ADDENDUM NUMBER 2

DATE: July 12, 2013
PROJECT: Elizabeth City Middle School Renovation Project
PROJECT NUMBER: 130083
OWNER: Pasquotank County
TO: Plan Holders
SENT VIA: A&E Reprographics
ATTACHMENTS: Asphalt Saw Cut Exhibit

ASPHALT SAW CUT EXHIBIT

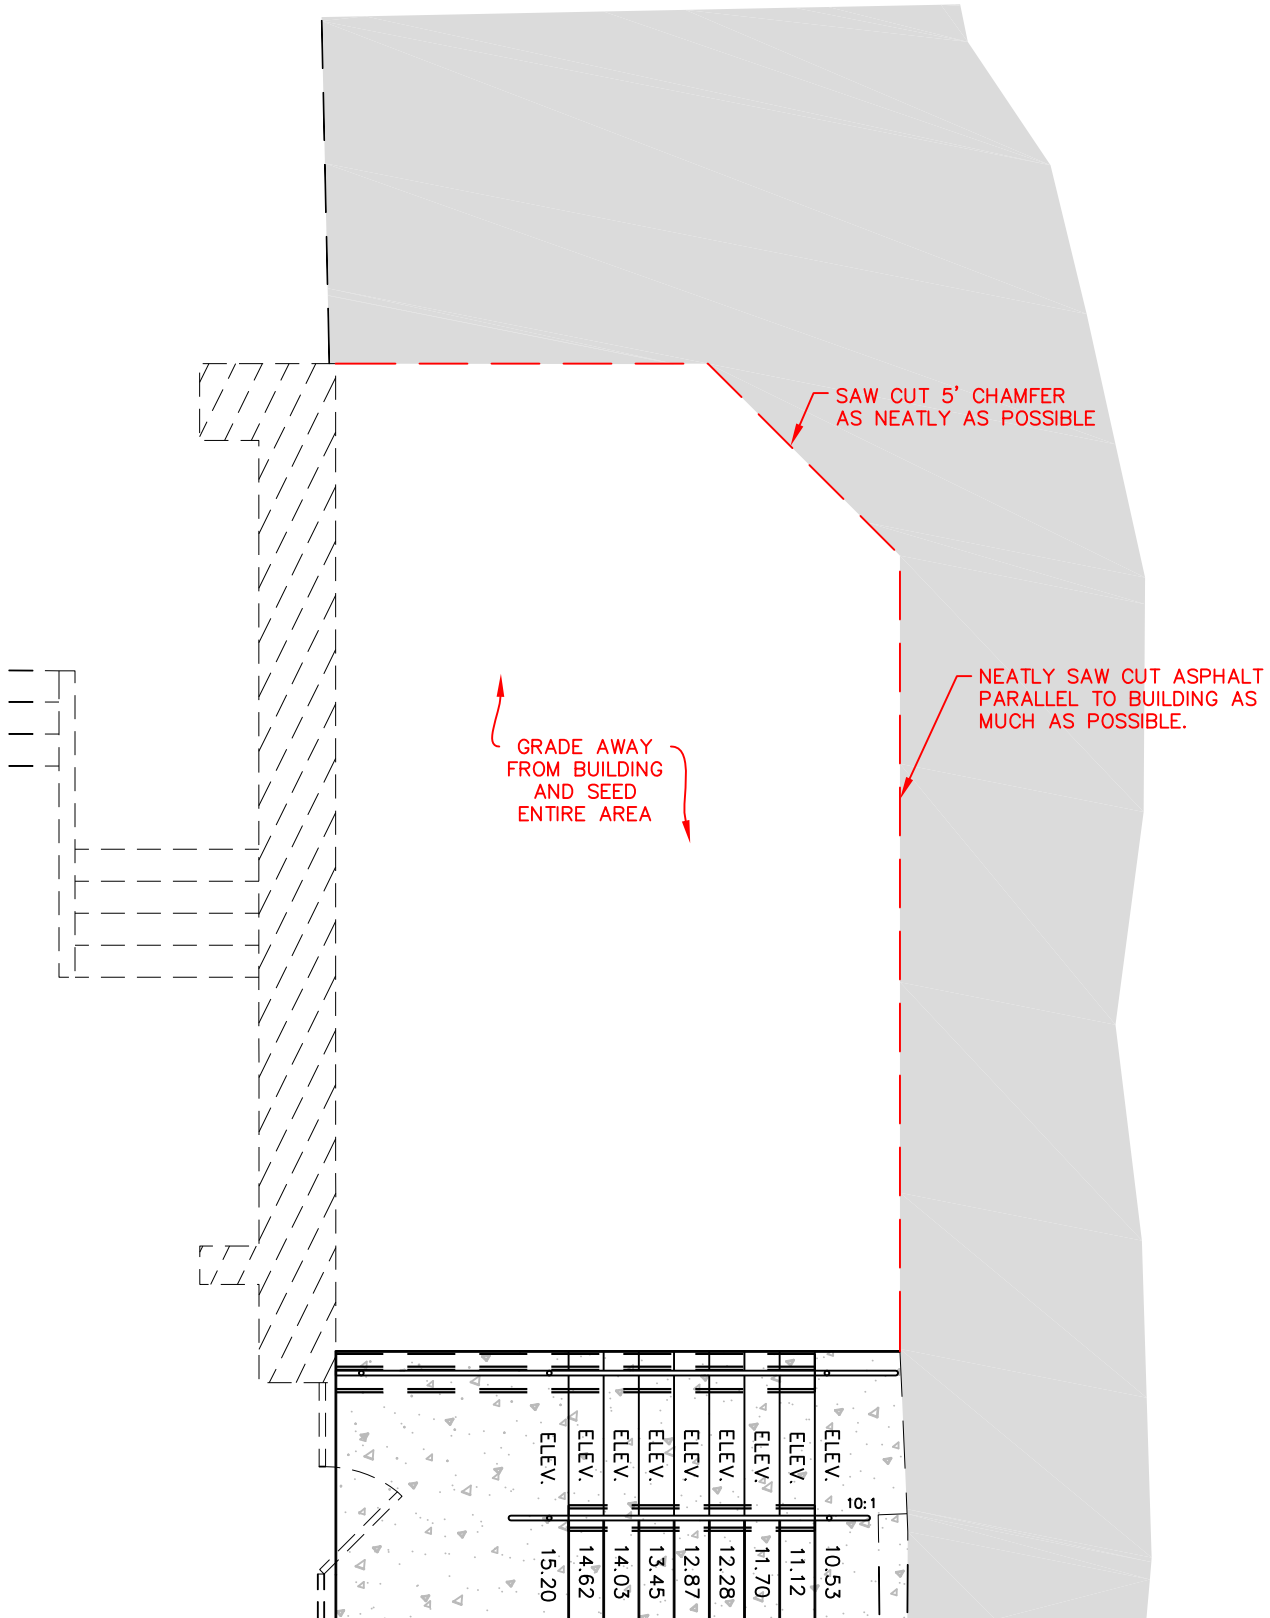
Question 5: When the ramp is demolished is the asphalt to be patched in the hole that is left?

Answer 5: Neatly saw cut the existing pavement according to the attached exhibit, “Asphalt Saw Cut Exhibit.” The area that is left after ramp demolition is to be graded such that water will flow away from the building. The area is then to be raked and seeded according to the specifications.
